**PLANNING COMMISSION REPORT**  
**Non-Public Hearing Item**

PC Staff Report  
09/21/2015

**ITEM NO. 3      FINAL DEVELOPMENT PLAN FOR BAUER FARM CREDIT UNION;  
4851 BAUER FARM DR (SLD)**

**FDP-15-00373:** Consider a Final Development Plan for Bauer Farm Credit Union, located at 4851 Bauer Farm Dr. Submitted by Landplan Engineering, for Free State Holdings, Inc., property owner of record.

**Figure 1A.** Development as shown on most recent approved Preliminary Development Plan, PDP-14-00055

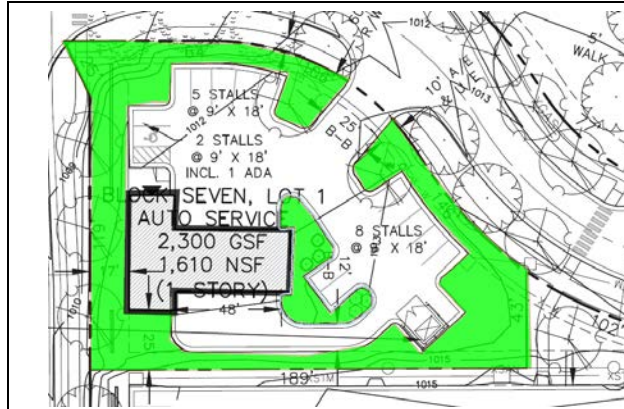
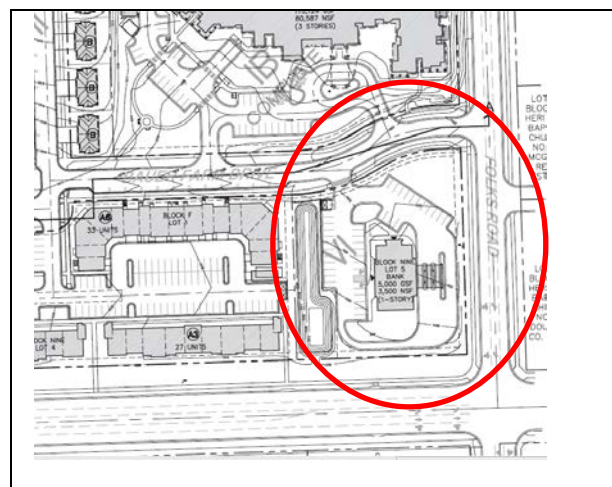
Figure 1 compares the lot layout on the approved Preliminary Development Plan (1A) and the proposed layout with the Final Development Plan (1B). The bank use was originally included in the Bauer Farm Planned Development as use in the POD portion of the development on the southwest corner of Bauer Farm Drive and Folks Road. This application relocates the use to the west end of the Planned Development. The previous plan shows this lot developed for an auto service use such as a quick lube type business.

The approved Preliminary Development Plan included a bank use located on Lot 5, Block 9 with 5,000 sq ft, 3 drive-thru lanes, 1 ATM lane and 42 parking spaces. This application reduces the intensity of the planned bank use and relocates it to the west side (PCD) of the Bauer Farm Planned Development.

1. Change in use from *Automotive Sales and Service Use* to *Financial, Insurance, Real Estate Office Use*.
2. Reduction of the overall building size from 2,300 sq ft to 2,110 sq ft.
3. Reduction of overall off-street parking from '9 required/15 provided' to '8 required/12 provided'.
4. Addition of cross access between subject property and commercial development to the south.

1. Does not impact the residential density. Land use intensity is reduced based on the off-street parking requirement between the two uses.
2. Reduces the total building area with this application.
3. Reduces the total area covered by a building by this application.

4851 BAUER FARM DRIVE  
LAWRENCE, KANSAS 66049  
FINAL DEVELOPMENT PLAN  
LAYOUT PLAN

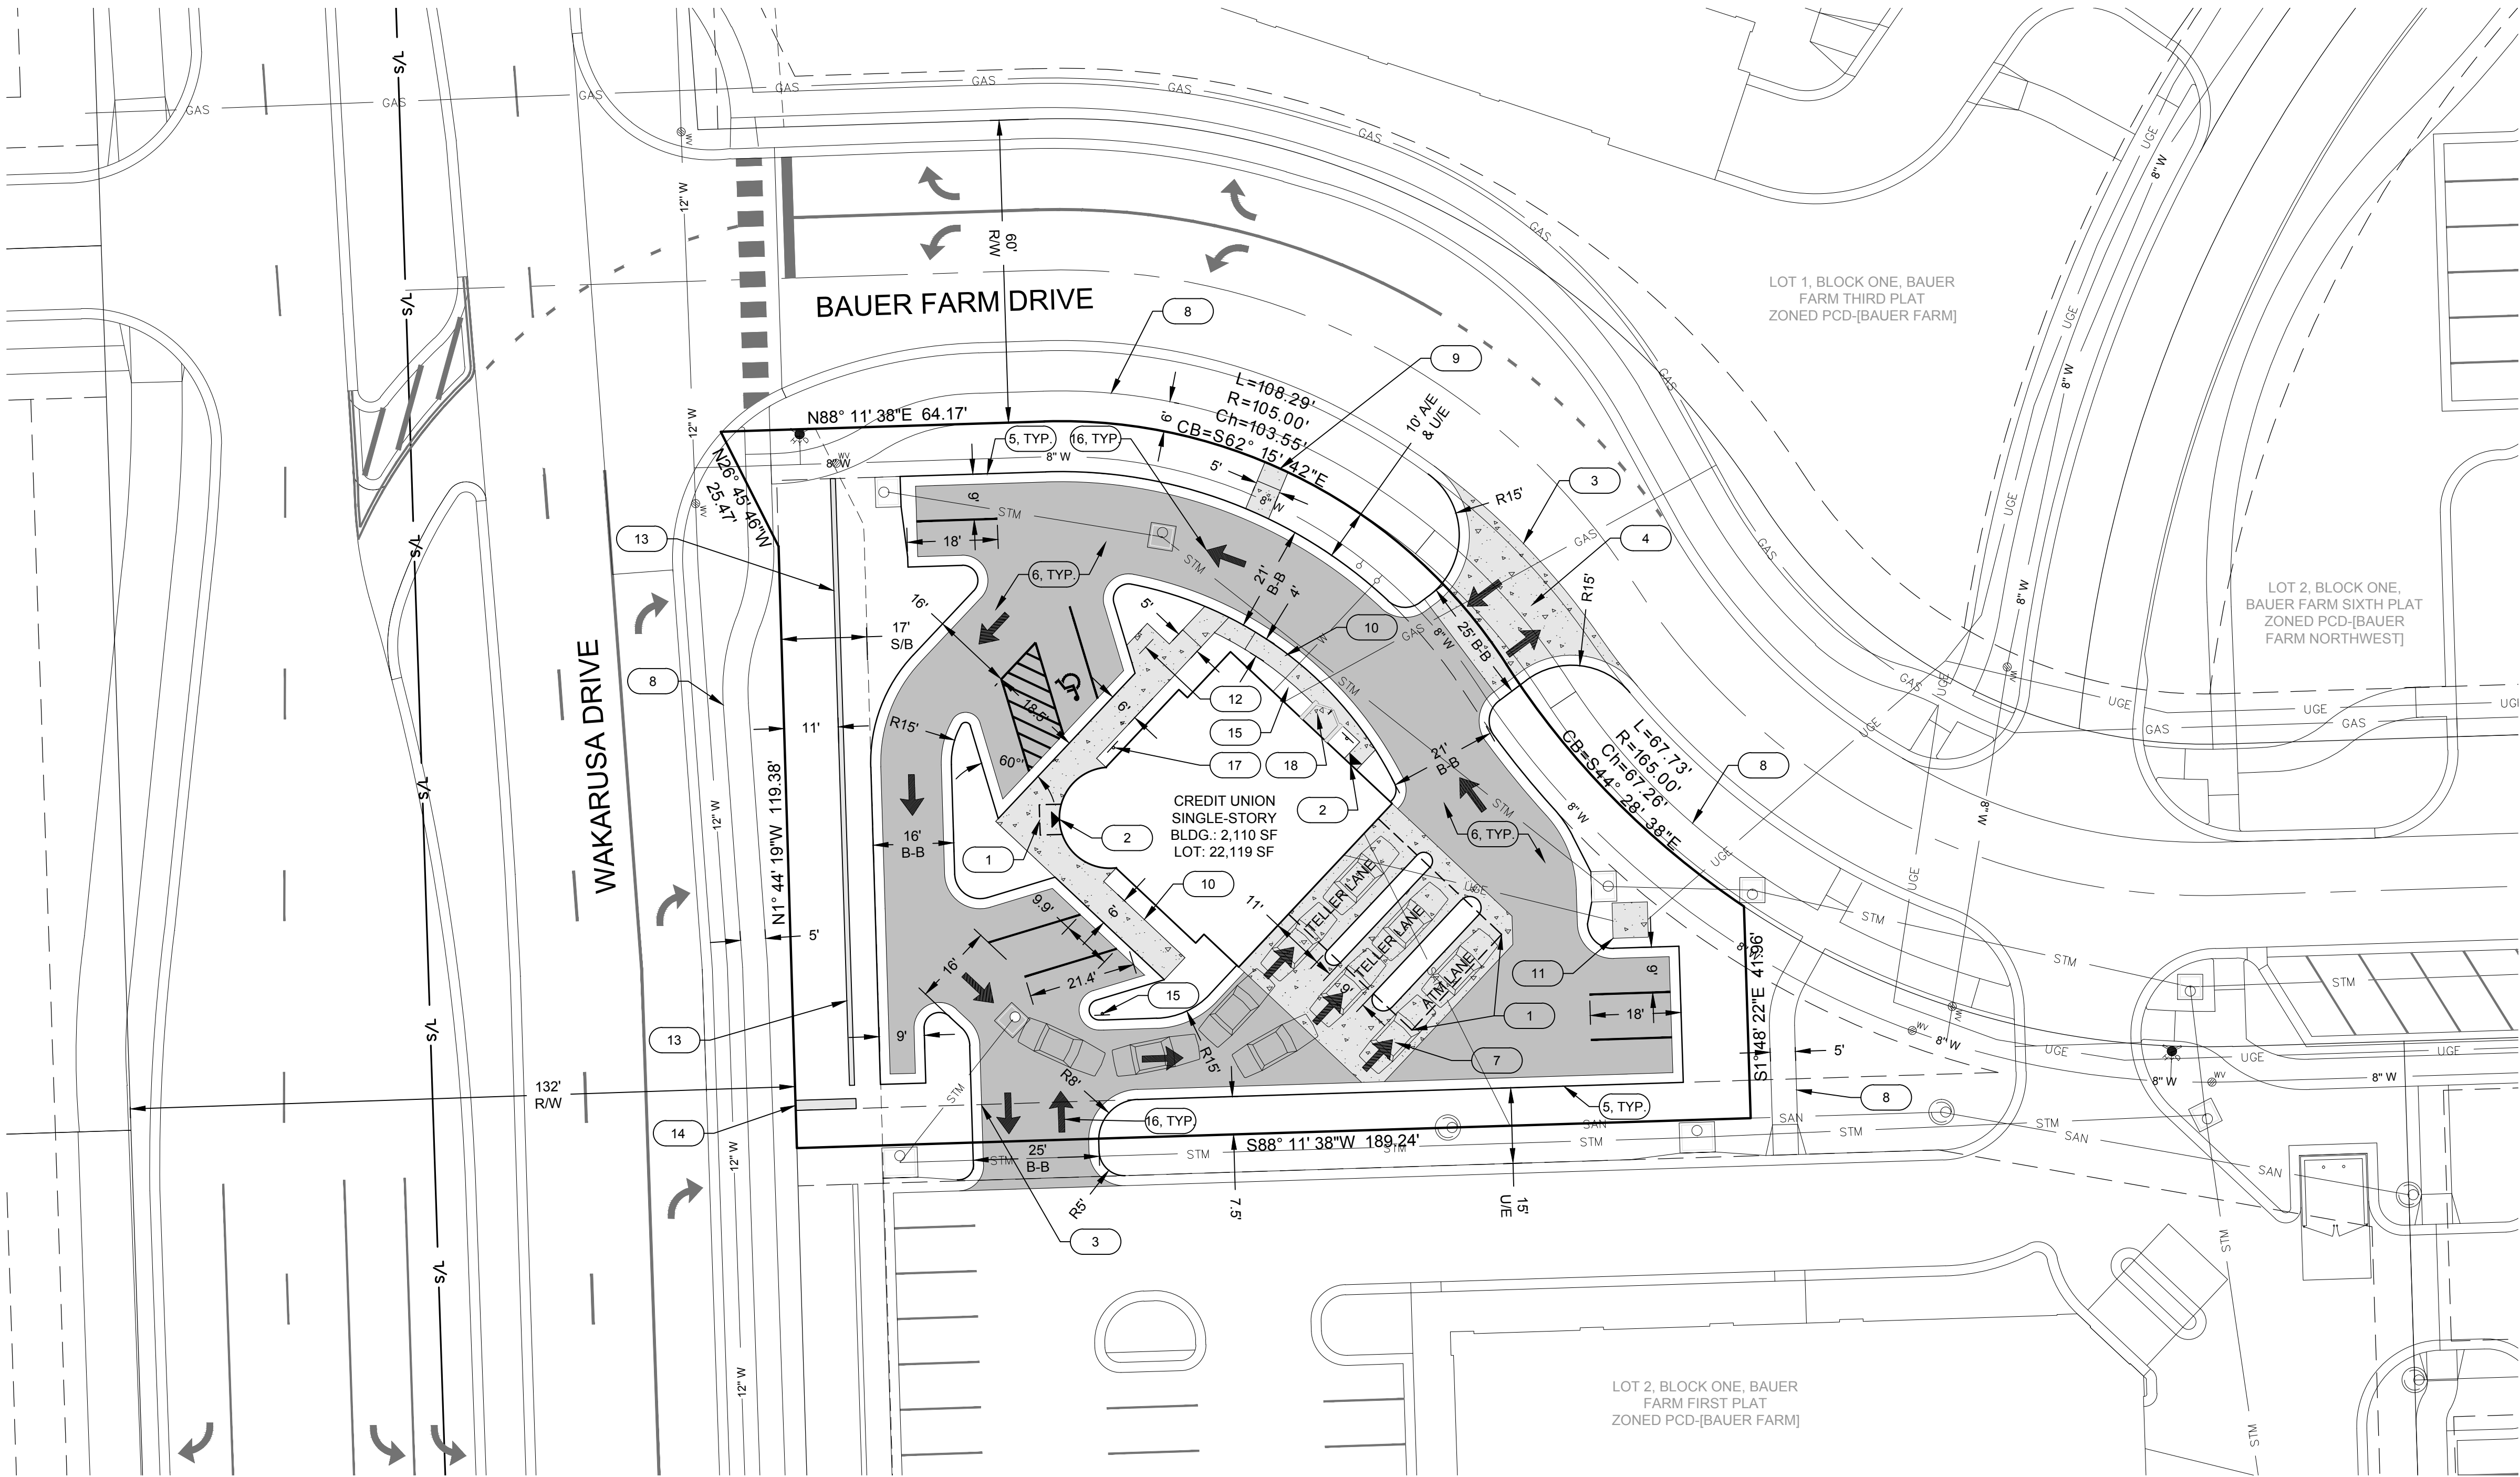
Vehicular access to this site is provided from Bauer Farm Drive and is consistent with that approved on the Preliminary Development Plan. Adequate bicycle parking is being provided and is being located near the main entrance. In addition to the access to Bauer Farm Drive this site includes a new access between the subject property and the adjacent commercial property to the south. This increases the internal site circulation. A condition of approval related to the access is to revise the plan to include a reference to the shared access easement between the two properties.

A photometric plan including a point by point illumination array is required to show the lighting levels and fixture type are compliant with the standards in Section 20-1103(d)(3). This requirement is reflected as a condition of approval.

Peripheral boundaries are not required between PUDs in the same development. Parking lots are also required to be screened. This application revises the parking lot design to orient spaces to the interior of the site. The previous plan included parking along Bauer Farm Drive. Interior parking lot islands are provided. Current design standards require 480 SF of interior green space. The proposed plan includes 907 SF of green space. This application exceeds the minimum required interior green space.

1. Applicant shall submit a photometric plan including a point by point illumination array to show the lighting levels and fixture type are compliant with the standards in Section 20-1103(d)(3) prior to release of the Final Development Plan for issuance of a building permit.
2. Applicant shall submit a copy of the written permission from the adjacent property owner for shared access along the south property line prior to the release of the Final Development Plan.
